Maserati Technical Bulletin

Date: January 15, 2019
Bulletin No. – MAS001749 – MTB 19-02 Fuel Delivery
Line Replacement - US
Safety Recall Campaign - #378
Supersedes: N/A

Model: Quattroporte (M156) and Ghibli (M157)

Subject: Vehicle Safety Recall Campaign #378 – Fuel Delivery Line Replacement

Fig.1

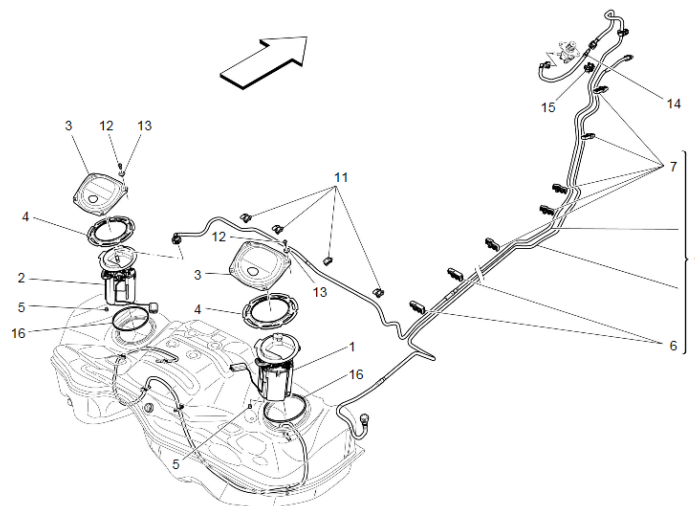
Maserati S.p.A. and MNA have determined that the above described vehicles were manufactured with plastic fuel lines (Num. 9 in Fig.1) that may have been damaged by foreign particles present during fuel line production and assembly by the supplier that may have scratched the inside of the fuel line eventually leading to a fuel leak. Leaking fuel may, in certain circumstances and in the presence of an ignition source, lead to a fire. A fire can result in increased risk of occupant injury and injury to persons outside the vehicle.

The original 1 piece fuel delivery line will now be replaced by the above kits which contain 3 lines. The engine connection line (1), the body line (2), and the fuel tank connection line (3).

Fig.18

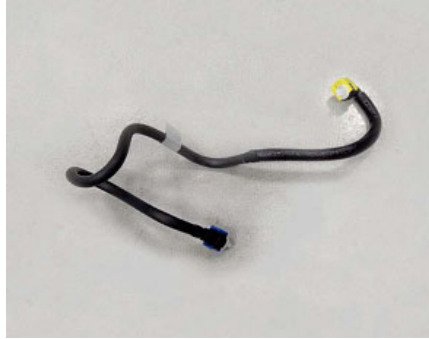
13. Replace the old fuel delivery line on the engine with the new fuel delivery line from the kit as shown in Fig.18.
